Access Compliance Report

Public Rights-of-Way

(Curb Ramps)

Intersection ID: 10022282	Main Street: CAMBRIDGE BELTWAY DR	Cross Street: N/A	Location: E
ADA ID: EAA12D6E8229	Ramp Type: PerpDiag	Initial Pass/Fail: Fail	Overall Compliance: No
Severity Score: 22.5			
Codes/Mitigation Info/Possible Solution		Field Measurements/Component Compliance

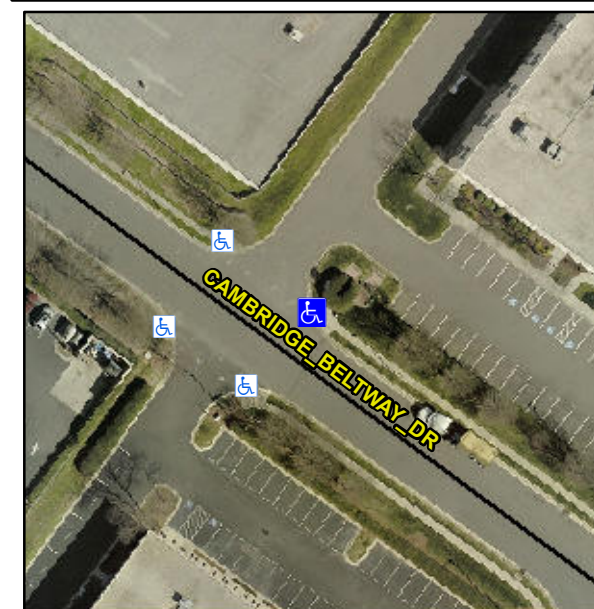
Not Found, R304.5.1, R304.2.2, R304.5.3

Compliance	Description	Data	Compliance	Description	Data
N/A	Ramp Length (in)	105.0	No	Ramp Slope (%)	10.1
No	Ramp Width (in)	44.0	No	Ramp XSlope (%)	4.3
N/A	Flare Type LT	N/A	N/A	Flare Type RT	N/A
N/A	Flare Slope LT (%)	N/A	N/A	Flare Slope RT (%)	N/A
N/A	Flare Traversable LT?	N/A	N/A	Flare Traversable RT?	N/A
N/A	Landing Length (in)	N/A	N/A	DWS Provided?	N/A
N/A	Landing Width (in)	N/A	N/A	DWS Contrast?	N/A
N/A	Landing Slope (%)	N/A	N/A	DWS Length (in)	N/A
N/A	Landing X Slope (%)	N/A	N/A	DWS Full Width?	N/A
N/A	Landing Curb? (Y/N)	N/A	N/A	DWS Offset (in)	N/A
N/A	Shared Landing?	N/A			
N/A	Gutter Ponding?	N/A	N/A	Gutter Slope (%)	N/A
N/A	Gutter Lip Ht (in)	N/A	N/A	Gutter X Slope (%)	N/A
N/A	Painted X Walk1?	No	N/A	Painted X Walk2?	No
	X Walk 1 Direction	To NW		X Walk 2 Direction	To SW
N/A	X Walk 1 Width (in)	N/A	N/A	X Walk 2 Width (in)	N/A
	X Walk 1 Slope (%)	0.8		X Walk 2 Slope (%)	1.4
	X Walk 1 X Slope (%)	4.5		X Walk 2 X Slope (%)	0.9

Remove & Replace Curb Ramp With Two New Directional Ramps or Equivalent.
